Technical Service Information

FORD E4OD/4R100 NEW FRONT PUMP ASSEMBLY FOR 1997-1998 MODELS

Figure 1

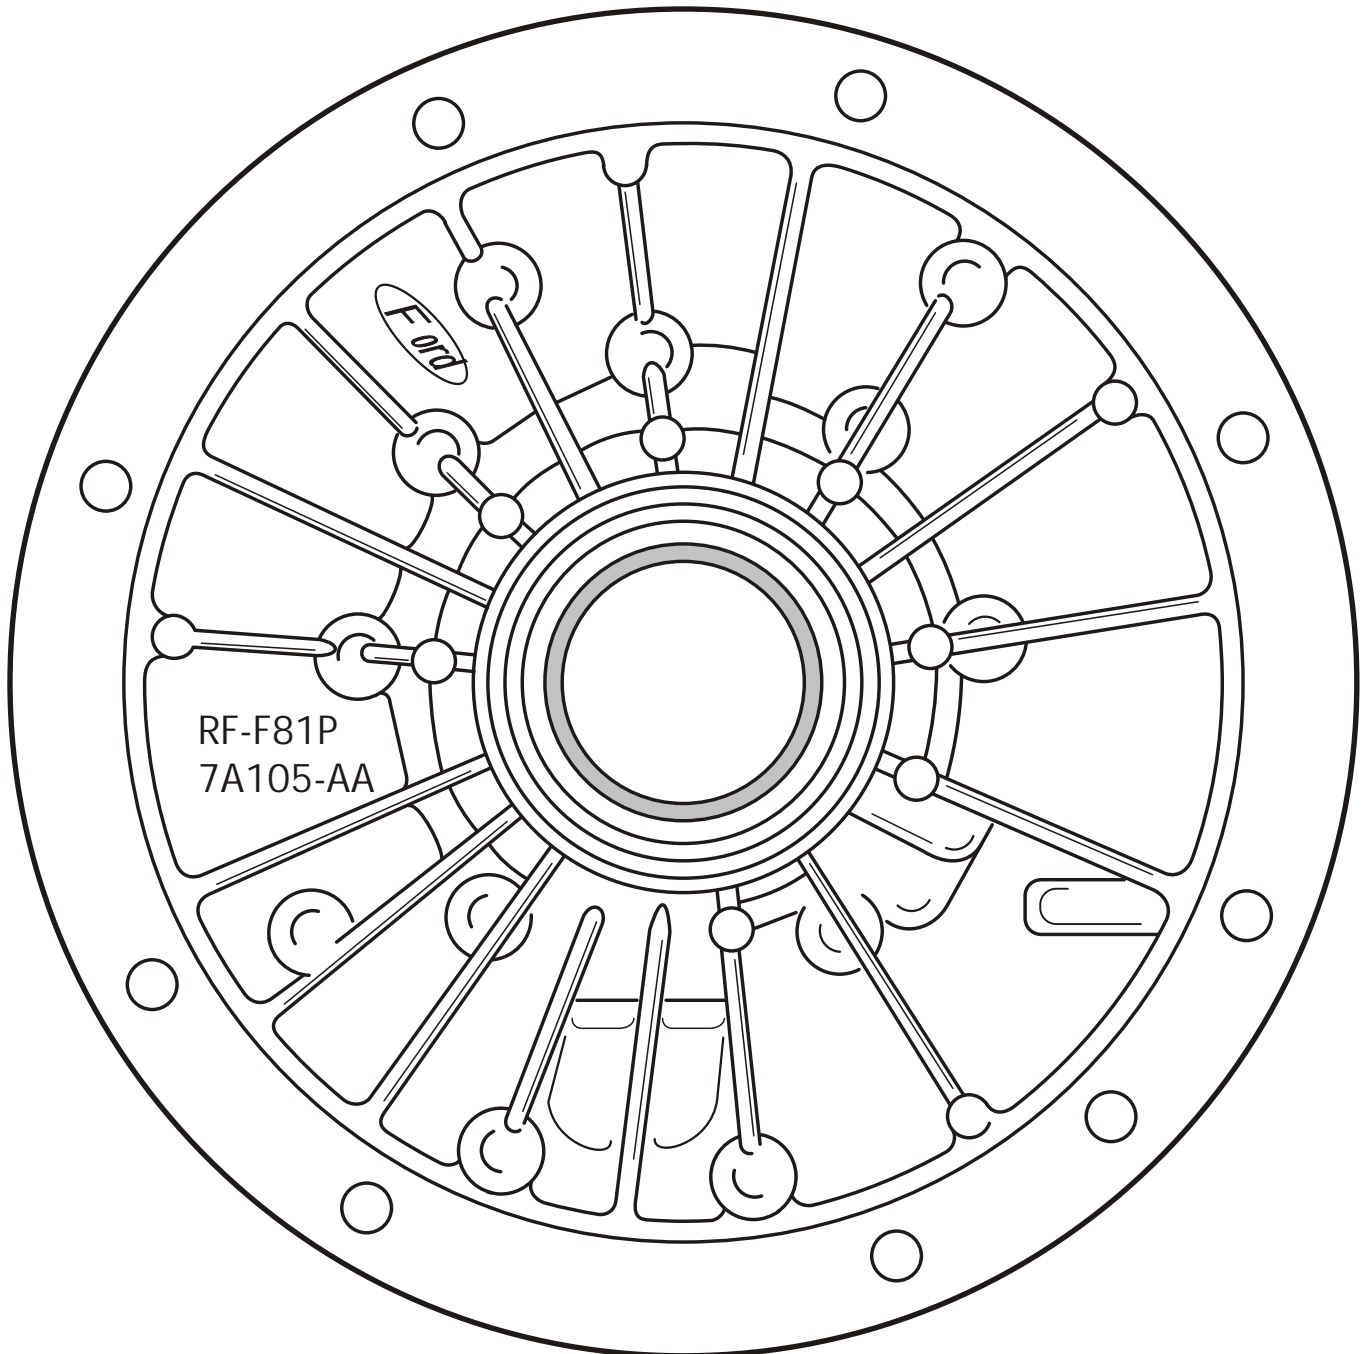
- (1) OIL PUMP BODY - Now has different worm tracks to accomodate the new pump cover assembly and is identified by the rough forging number RF-F81P-7A105-AA, and is cast into the pump body in the location shown in Figure 1. The worm track side of the new pump body and the previous pump body are shown in Figure 2.

Figure 3

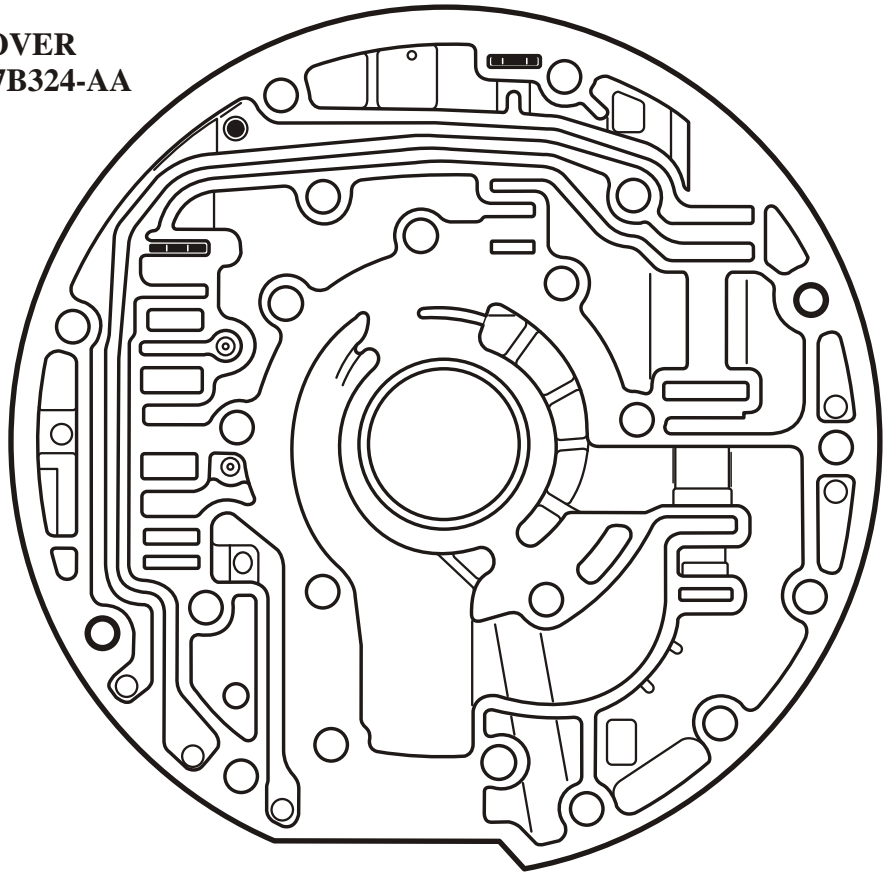
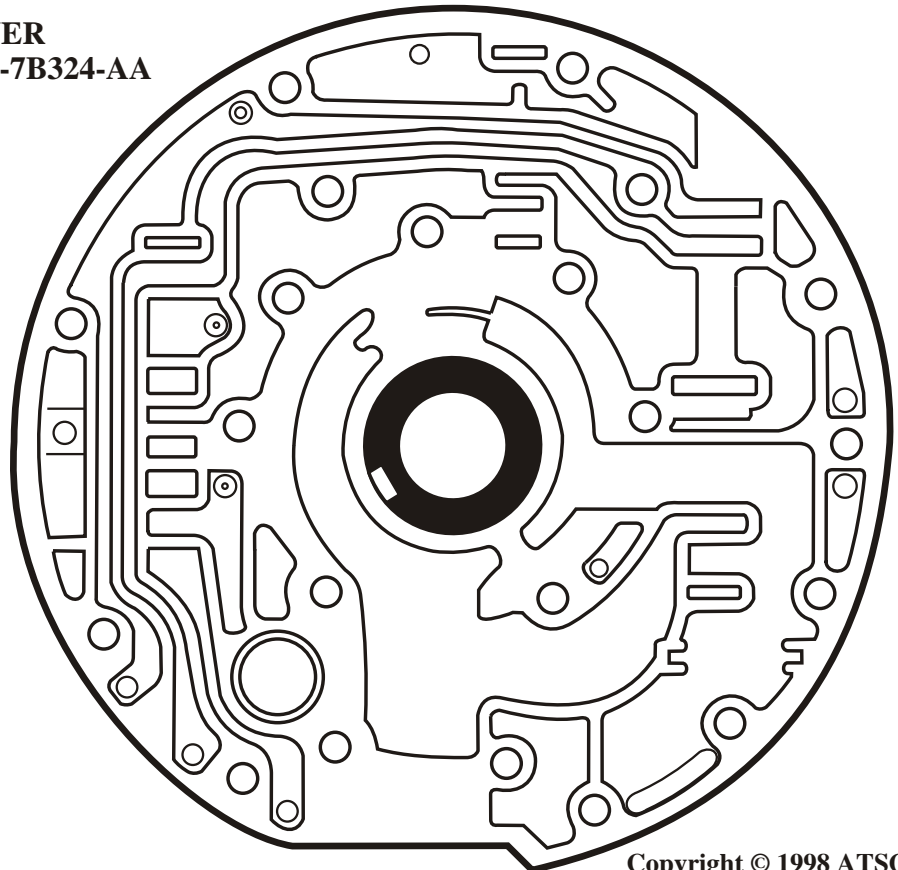
- (2) OIL PUMP COVER - Now has different worm tracks to accomodate two different styles of converter clutch valve line-ups, and has one added bolt to clamp the pump halves together. The worm track side of the new pump cover and the previous pump cover are illustrated in Figure 3, and casting number on new pump cover is RF-F81P-7B324-AA for identification.

Figure 4

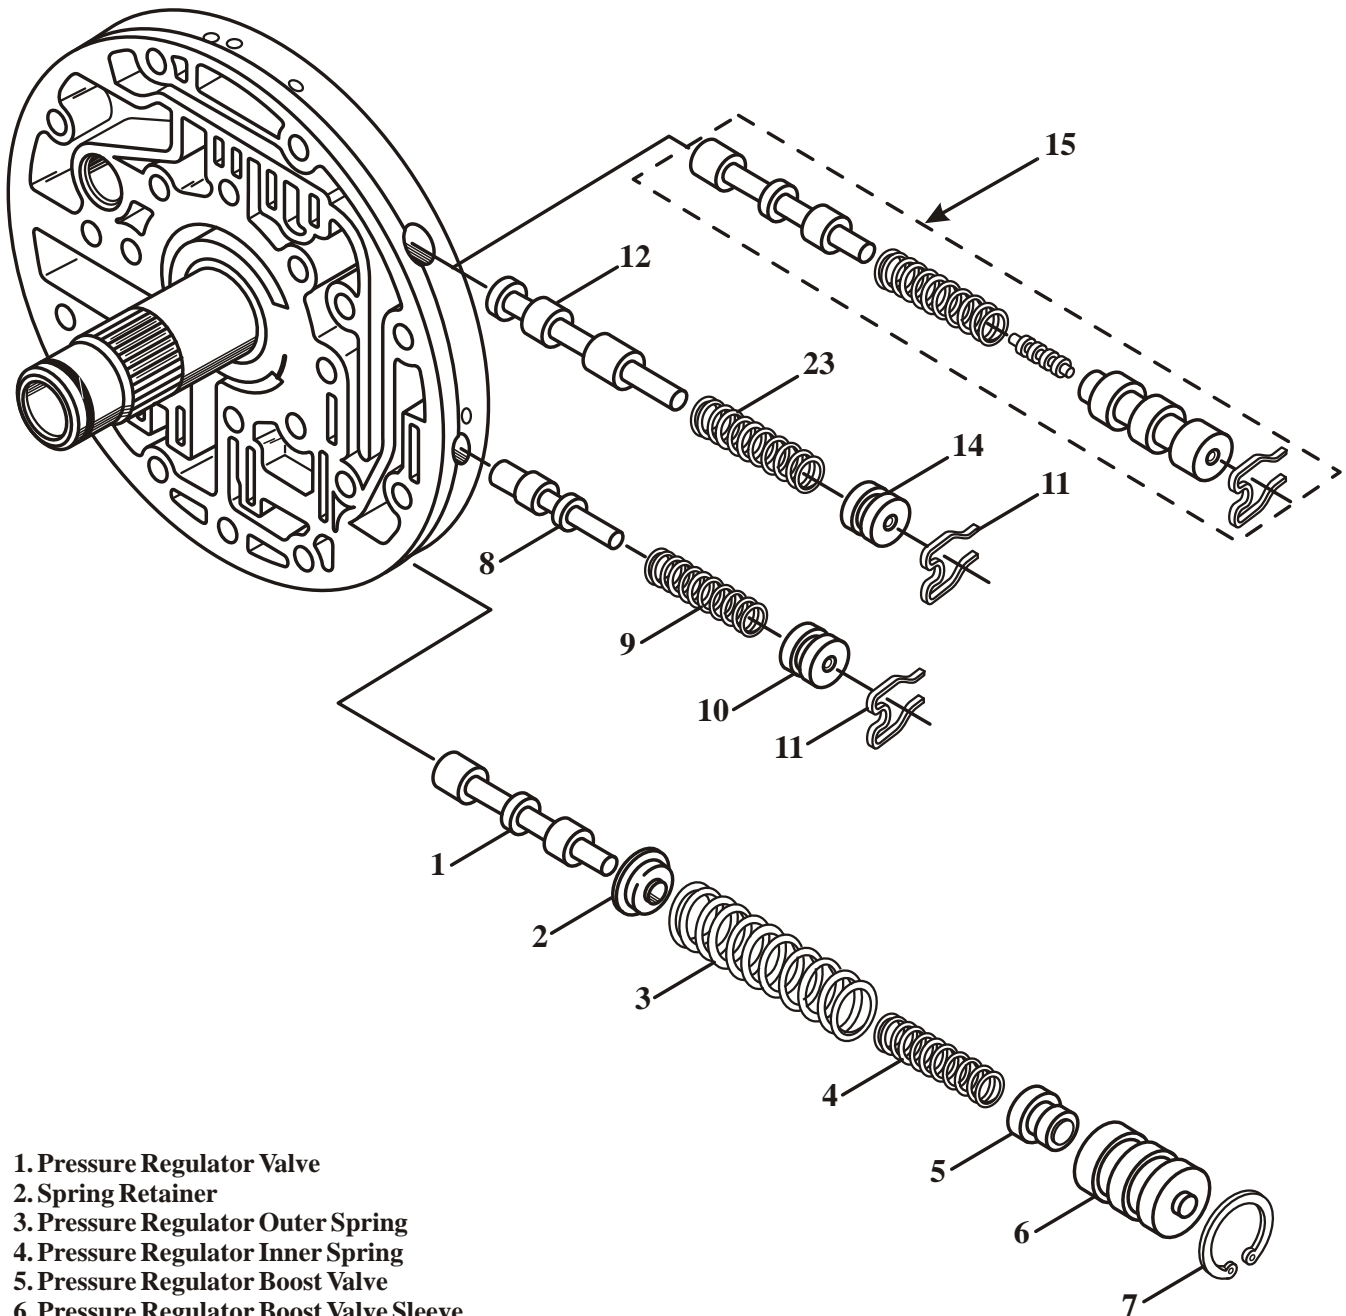
- (3) TCC LINE-UP - There are now two different Converter Clutch Control Valve Line-Ups in the oil pump cover depending on whether it is gasoline or diesel engine. Both of these valve line-ups are illustrated in Figure 4.

Figure 5

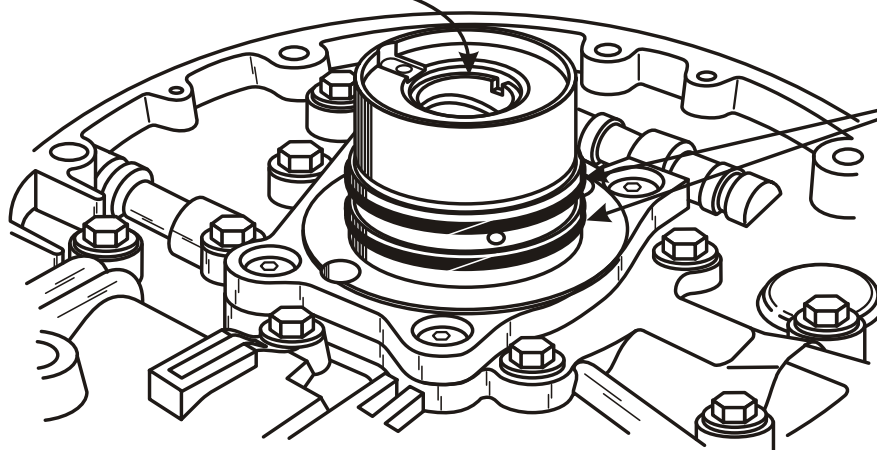
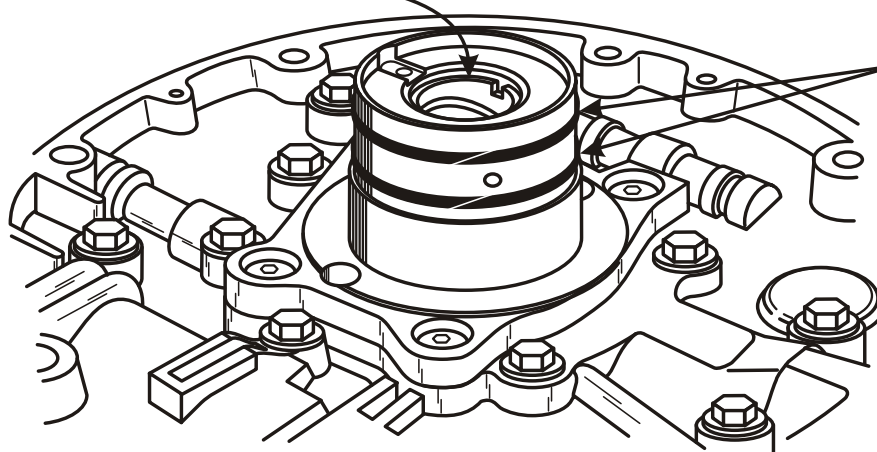
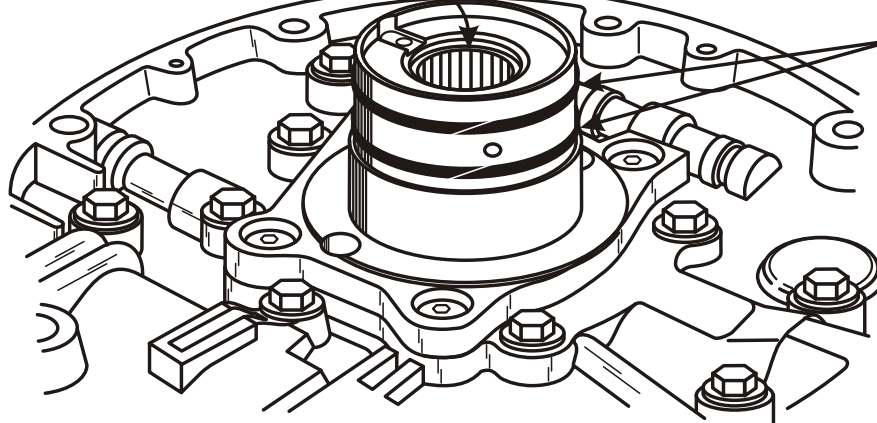
- (4) STATOR SHAFT ASSEMBLY - There are now three different Stator Shaft Assemblies with different sealing ring and bushing configurations, to accomodate the PTO and a new coast clutch housing, as illustrated in Figure 5, and are model dependent.

COAST CLUTCH
SEAL RINGS ARE
LOW ON PUMP TOWER
(LIKE E40D)

COAST CLUTCH
SEAL RINGS ARE HIGHER
ON THE PUMP TOWER

COAST CLUTCH
SEAL RINGS ARE HIGHER
ON THE PUMP TOWER

Figure 6

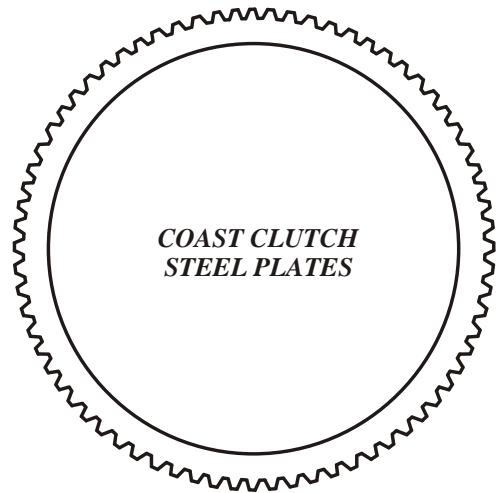
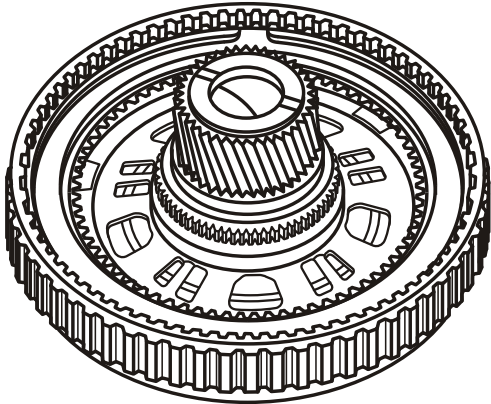
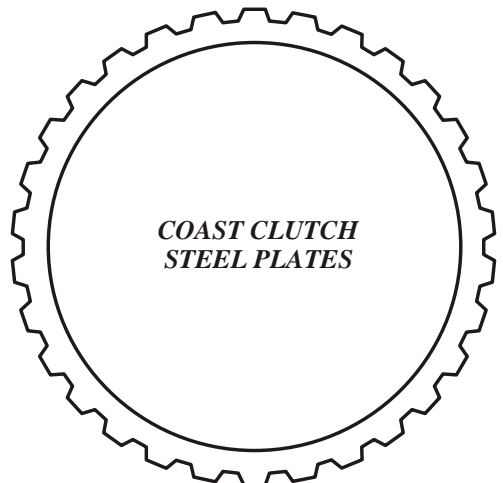
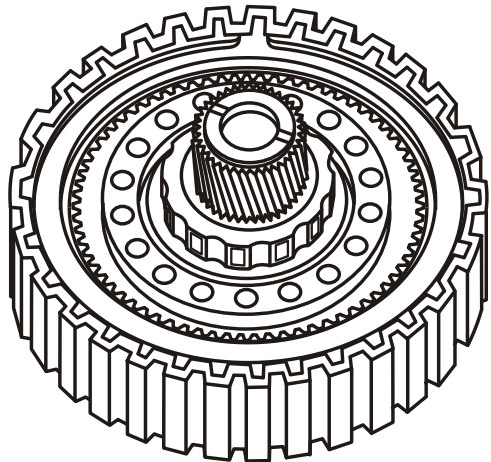
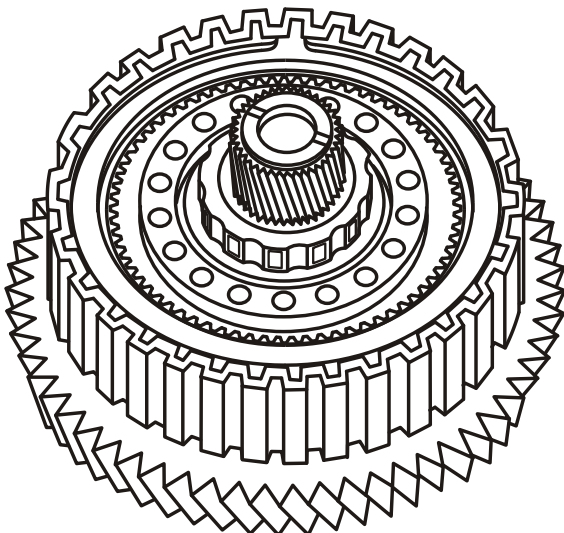
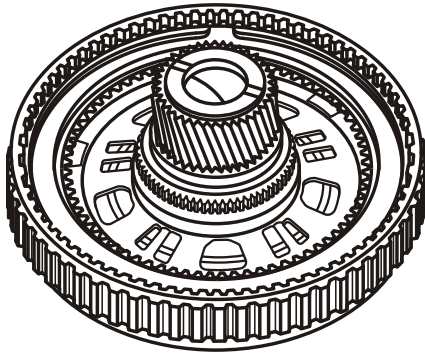
- (5) COAST CLUTCH HOUSING - There is now a "stamped Steel" coast clutch housing that may or may not have a PTO gear pressed onto the housing, that is used in addition to the previous cast iron coast clutch housing, depending on the model and engine size, and is illustrated in Figure 6. This also changes the coast clutch steel plates and the fourth clutch friction plates, as shown in Figures 6 and 7.
